## **ADDENDUM**

**PROJECT:** Forestside Estates  
Attmar & Palleschi Drive  
Brampton, Ontario

**PROJECT NO.:** 18-017

**ADDENDUM NO.** E-3

| DRAWN     | CHECKED | SCALE   |
|-----------|---------|---------|
| MAY, 2019 | 18-017  | E-2C    |

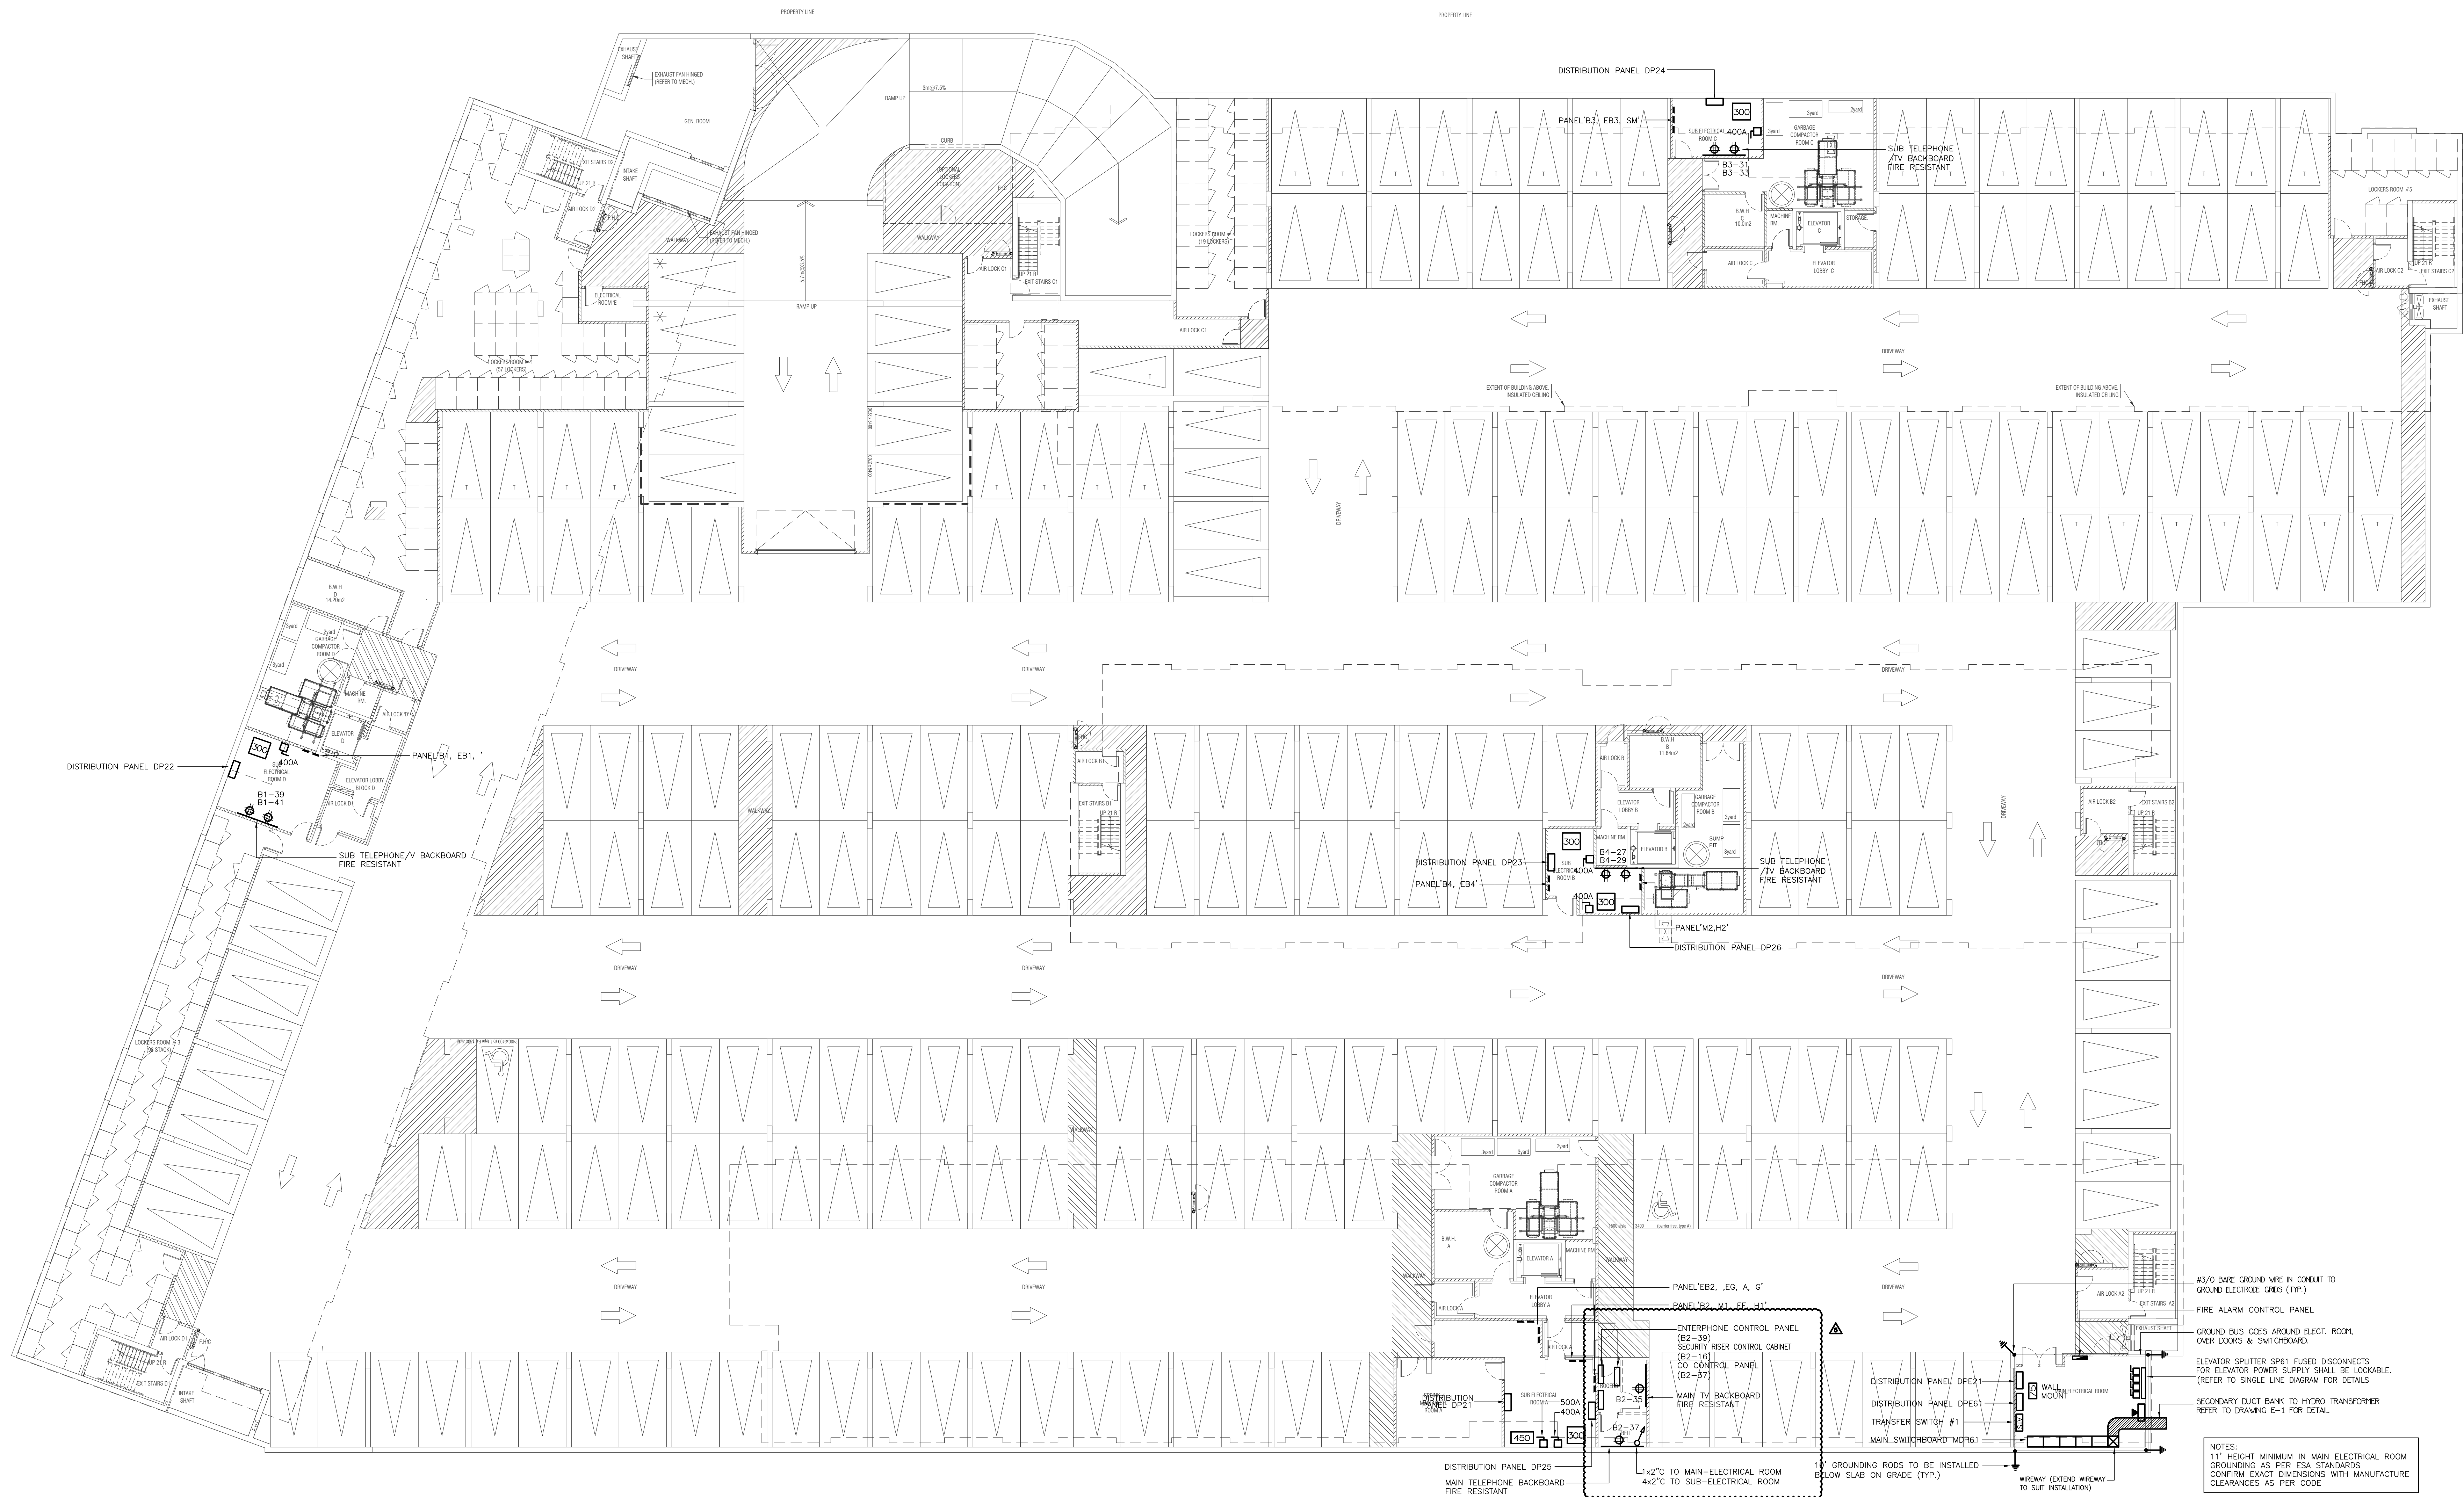
**1.0 Reference Drawings E-2A (Parking Level Part A - Electrical) Issued**  
**E-2B (Parking Level Part B - Electrical)**  
**E-2C (Parking Level Electrical Room Layout)**

1.1 Revise: Electrical layout to suit latest arch drawings as shown.
